Wisconsin Department of Transportation

Proposal #02: 5255-01-81, WISC 2020 345
Mineral Point – Spring Green
Wisconsin River Structure B-25-0051
STH 23
Sauk & Iowa Counties

This is Addendum No. 02, which provides for the following:

| PROJECT NO: 5255-01-81 | COUNTY: IOWA, SAUK | PROPOSED TYPICAL SECTIONS: STH-23 | SHEET 5 |

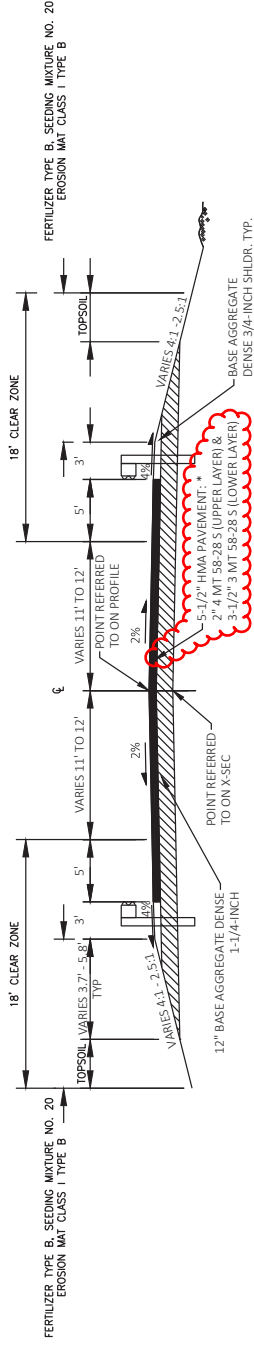
| Revised Plan Sheets | |
|----------------------------|---|
| 5 | Proposed Typical Section (Revised to reflect two lifts of HMA in place of Asphaltic Surface) |

* STA 430+01 TO 440+00 -
REMOVING ASPHALTIC SURFACE MILLING (4-INCH)
4" HMA PAVEMENT:
2" 4 MT 58-28 S (UPPER LAYER) &
2" 3 MT 58-28 S (LOWER LAYER)

Addendum No. 02
 ID 5255-01-81
 Revised Sheet 31
 July 7, 2020

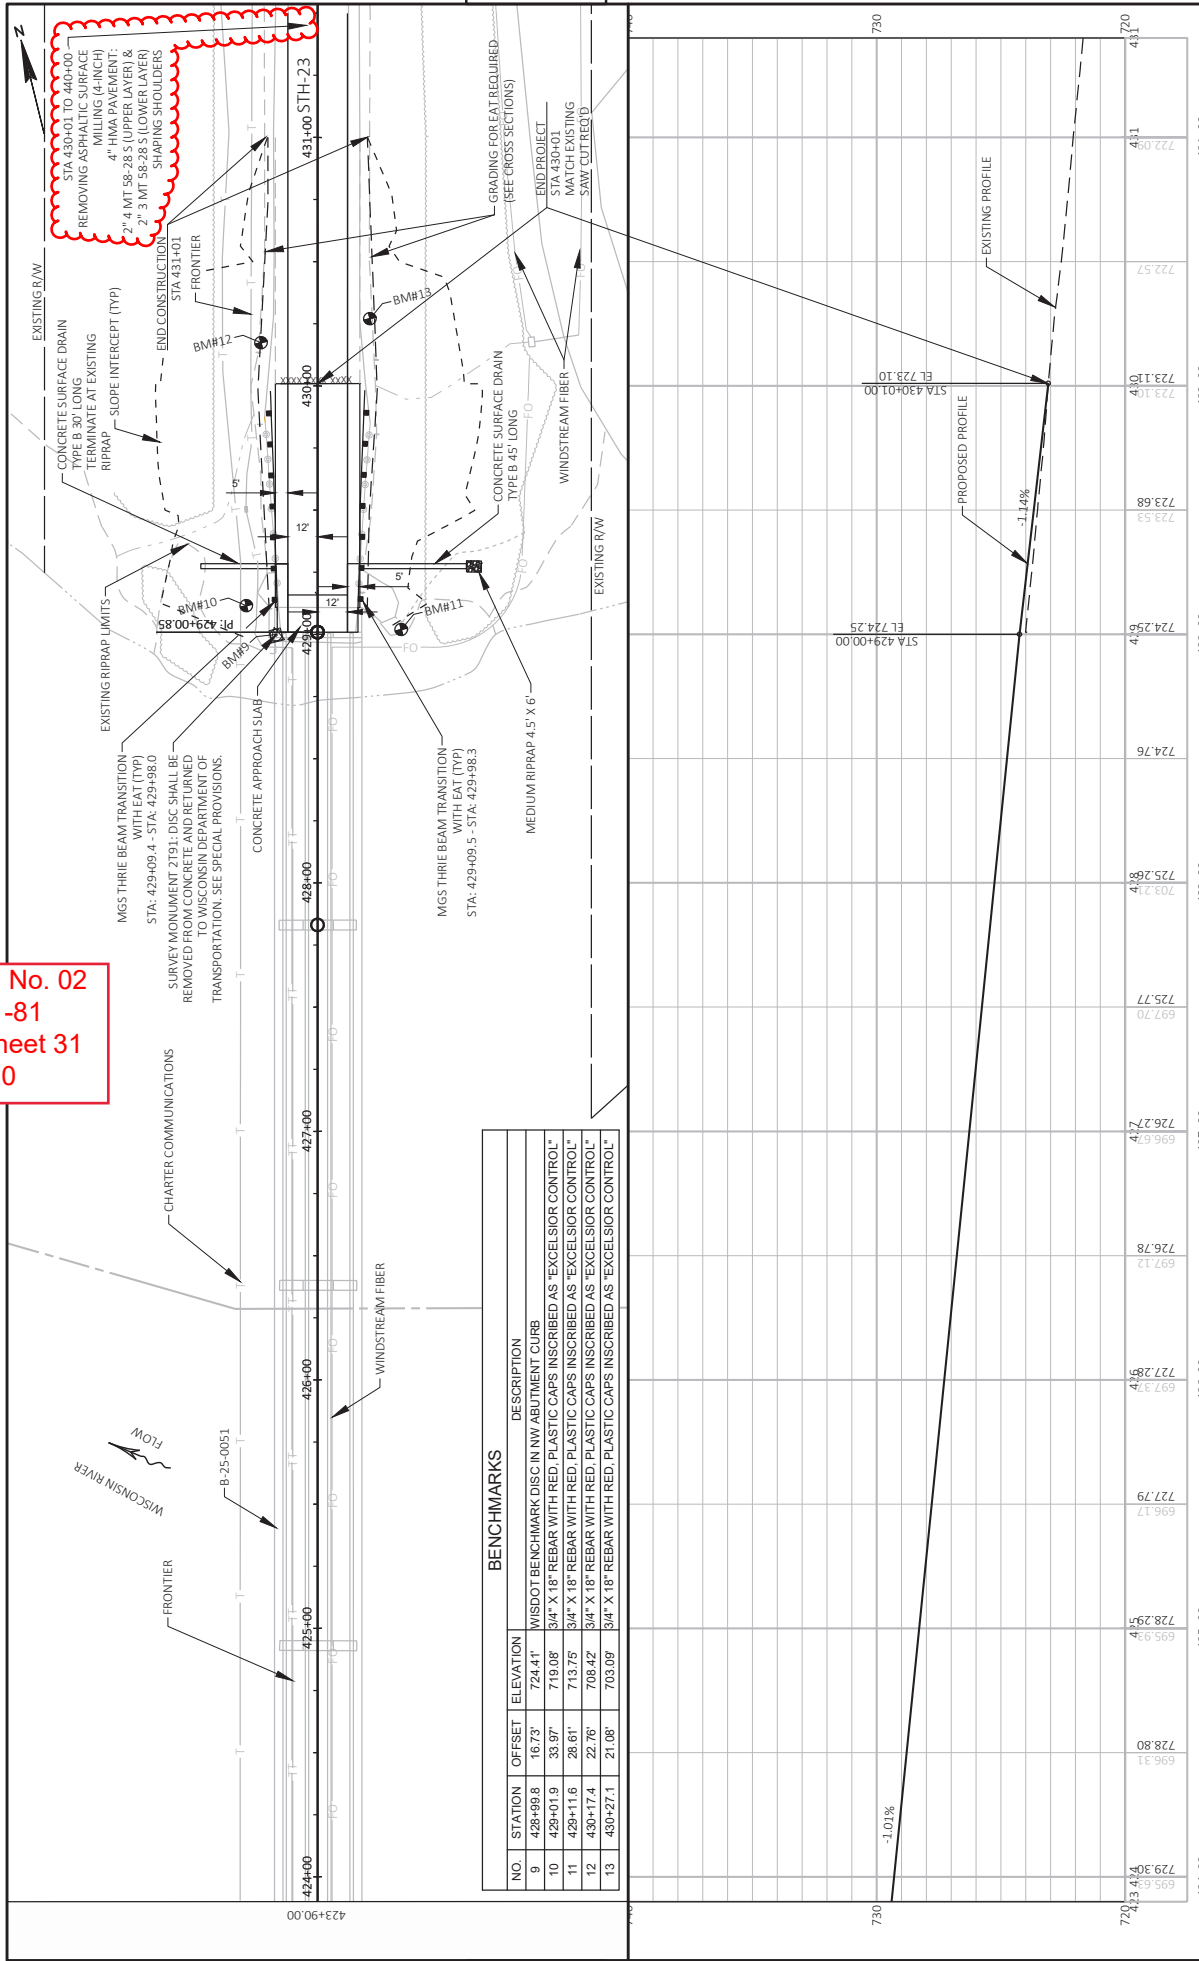
| Revised Plan Sheets | |
|----------------------------|---|
| 31 | Plan and Profile: Sta. 423+90 To End Of Project (Added call out detailing additional Mill and Resurfacing work) |
